SB-10052549-8694

Repair Notice

413-1

2013 Cummins After-Treatment Fuse Rating

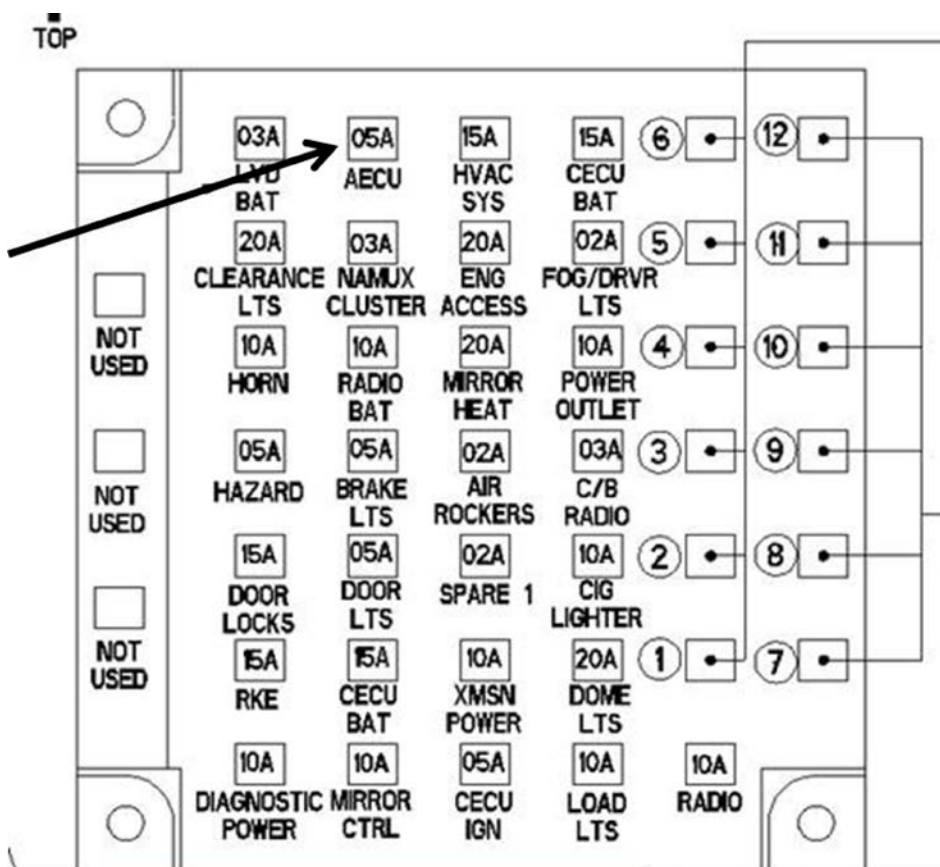
It has been determined that all Conventional Model and Model 320 vehicles built with a Cummins 2013 EPA engine before 02/21/2013 may experience a loss of power to after-treatment components. Model 567/579/587 is NOT included in this campaign.

Peterbilt will reimburse the dealer, dealer net + 30% to replace the 5 AMP fuse labeled AECU in the fuse panel with a 10 AMP fuse. Part number is M1N10.

Change the 5 AMP fuse with a 10 AMP fuse on all eligible trucks. See attached procedure below for location of the AECU 5Amp fuse.

Replace 5 AMP fuse AECU with a 10 AMP
